CHANGE ORDER SUMMARY
 CITY OF NORMAN
 CLEVELAND COUNTY, OKLAHOMA

CHANGE ORDER NO.: 02

PROJECT: Westwood Family Aquatic Center

CHANGE ORDER DETAIL
CHANGE ORDER NO. 2
City of Norman
Cleveland Co., Oklahoma

Detail A-SP-F2, Key Notes 178, 179, and 180 were intended to detail the following...

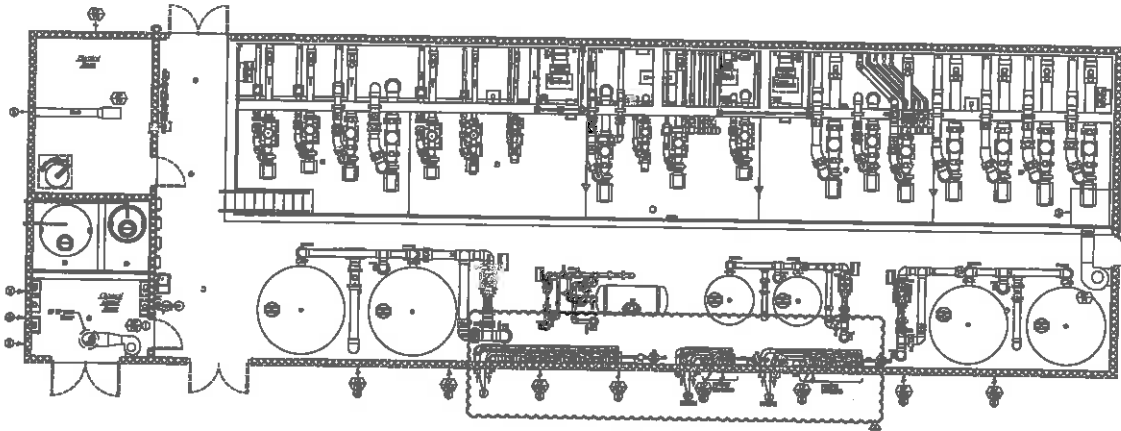
- Lap-diving pool heat system as an alternate bid item
- Rec pool heat system as a future item
- Lazy river-plunge area heat system as a future item

However, that was not clear, and the rec pool and lazy river-plunge area heat systems were included in the base bid.

Please provide a cost deduct to omit the following...but still allow for them to be added in the future...

- Rec pool heat system
- Lazy river-plunge area heat system

Mark Pleva, pool heat system mfr. and contractor, has expressed interest in providing a submerged heat exchanger in the lap-diving pool surge pit, in lieu of the specified exposed dry flat plate...this will provide a more efficient heat system. This is acceptable to WEAD.

Furnish and install an additional (2) burner units with gas hookups, and a submerged heat exchanger in lieu of the dry flat plate. Additionally, deduct the heaters at the lazy river and rec pool. All per WEAD RFP #01, and Detail 4 on SP-M4 dated 4/20/17			MATERIAL		LABOR		SUBCONTRACTOR	
DESCRIPTION	QUANTITY	UNIT	UNIT	COST	UNIT	COST	UNIT	COST
Subcontractor								
Capri Pools				0	0.00	0.00		0
Provide an additional (2) burner units and a submerged heat exchanger in lieu of the dry flat plate. Give Deduct for the future lazy river and rec pool burner units.	1	bid		0	0.00	0.00	-28,000	-28000
Mallett Plumbing				0	0.00	0.00		0
Furnish and install 3/4" gas lines off original gas trunk for the (2) additional gas heaters as shown in detail 4 of SP-M4 dated 4/20/17.	1	bid		0	0.00	0.00	901	901
General Contractor				0	0.00	0.00		0
General Expenses				0	0.00	0.00		0
As-build Drawings	1	hrs		0	71.02	71.02		0
Estimating	0	hrs		0	63.92	0.00		0

4 Natural Gas Piping Riser Diagram
Scale: None

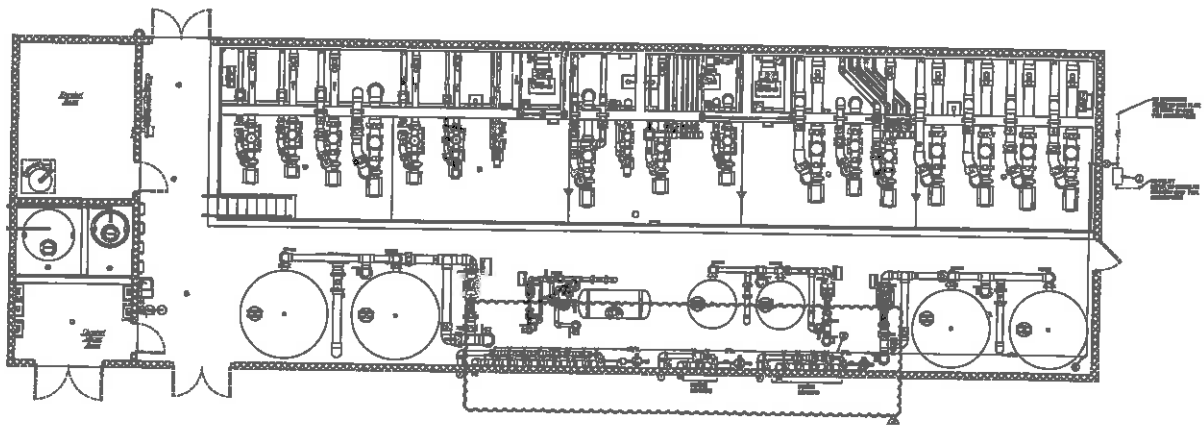
-- Piping figured based on ISO Detail 4 on SP-M4

Add (2) Additional 3/4" Gas Lines Off Proposed Gas Trunk in Filter Building
